RESAR-41
AMENDMENT 24
INSTRUCTION SHEET

Extension Review Matters for
Preliminary Design Approvals

EXTENSION REVIEW MATTERS FOR PRELIMINARY DESIGN APPROVALS

Figure 3B-1 Comparison of Tensile Stress for Bolts

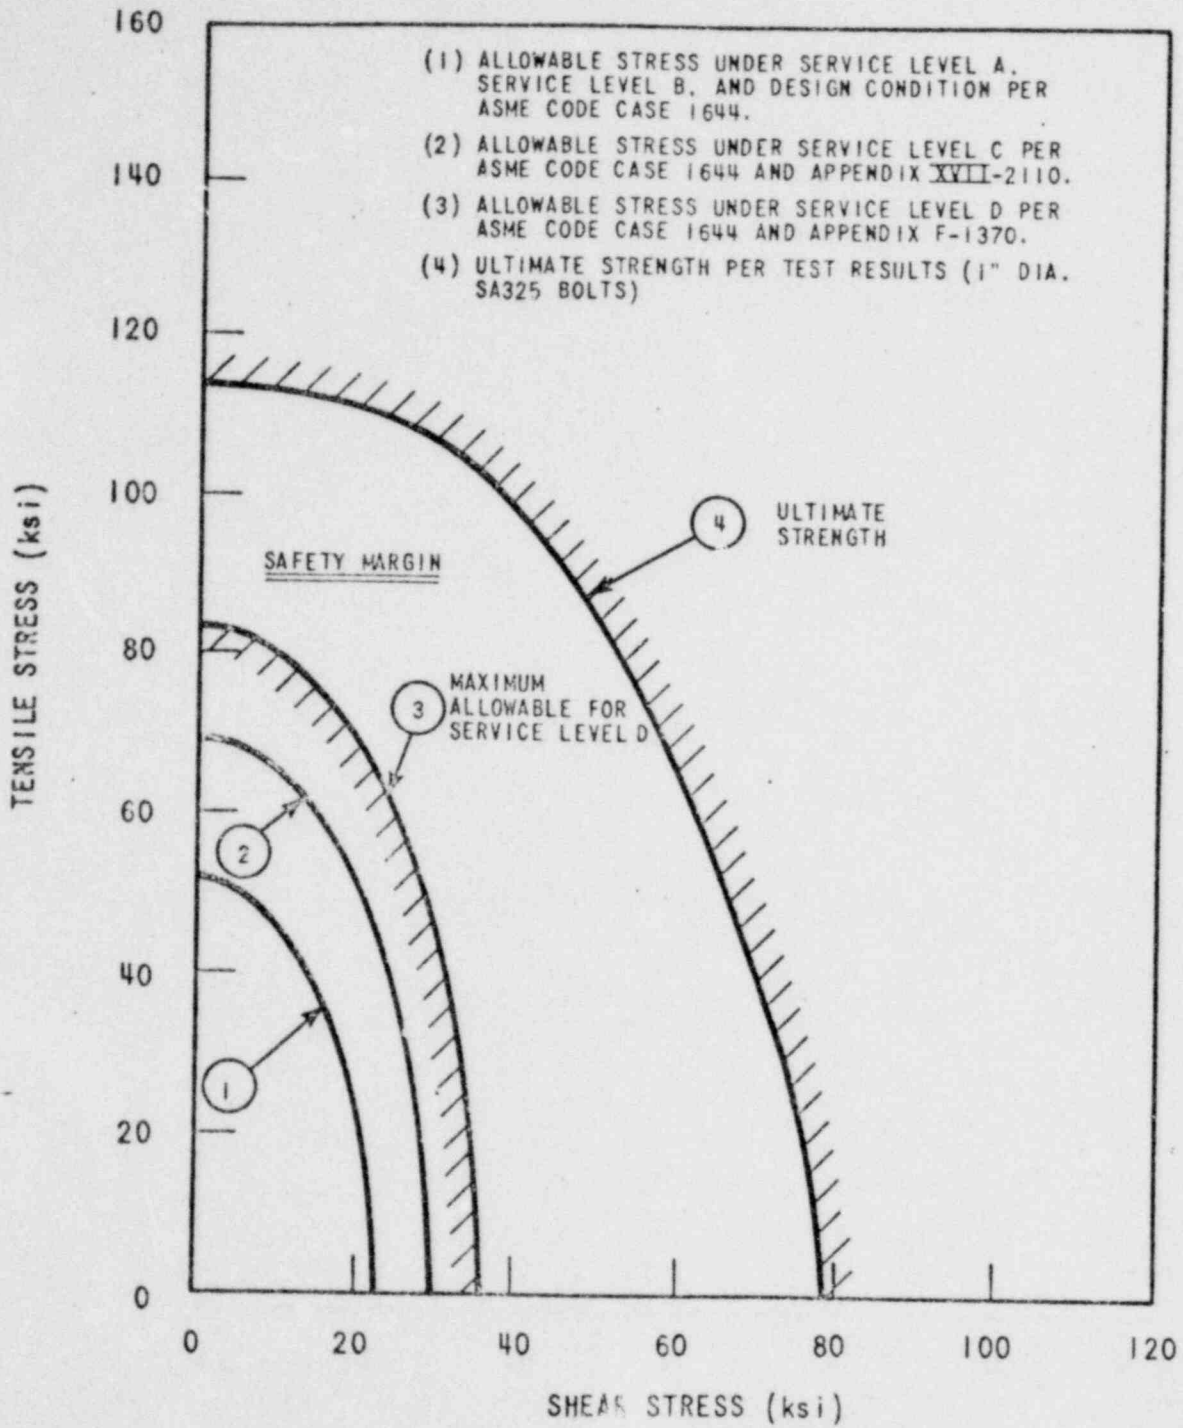
Figure 3B-1 shows the interaction curves for T-S loads on SA325 bolts. Curve (1) represents the interaction relation (ellipse) permitted by Code Case 1644 (ASME III Appendix XVII Winter 77 Addenda) for service levels A, B and design condition. Curve (2) represents the interaction curve which considers the Code Case 1644 allowables and the increase permitted by XVII-2110(a) for service level C. Curve (3) represents the interaction curve which considers the Code Case 1644 allowables and the increase permitted by F-1370(a) for service level D. Curve (3) is the upper limit of the allowable stresses.

Figure 3B-2 Factor of Safety Against Failure Under Service Level D as a Function of T-S Ratio

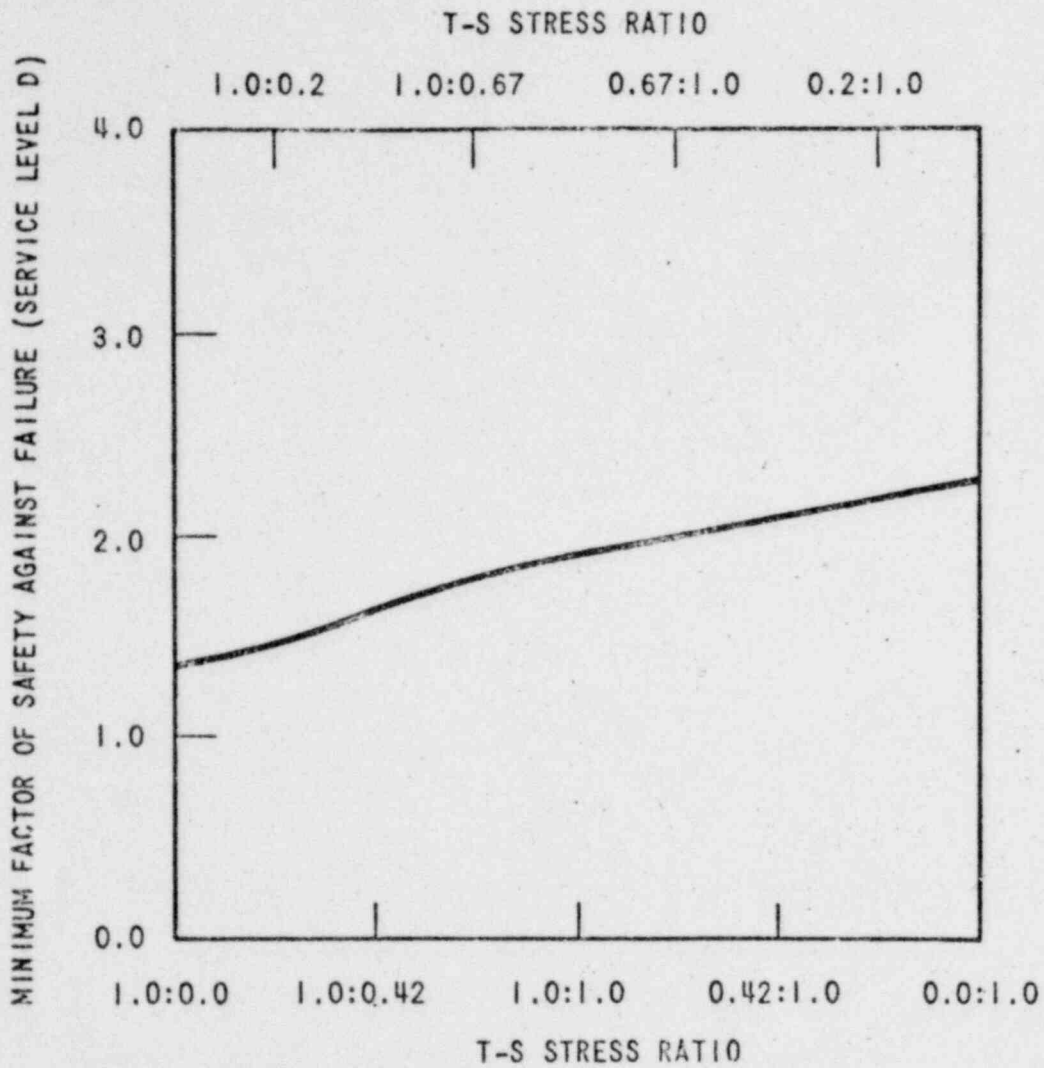
Factor of safety against failure for A325 bolts for various T-S ratios is shown in Figure 3B-2. The safety factor varies between a minimum of 1.36 and a maximum of 2.29 depending upon the value of T-S ratio. This is based upon the ultimate strength of the bolts from Chesson's test and the allowables obtained from Code Case 1644 and the increase permitted by F-1370(a) for service level D. Figure 3B-2 demonstrates that there exists an adequate factor of safety for the complete range of T-S loadings.
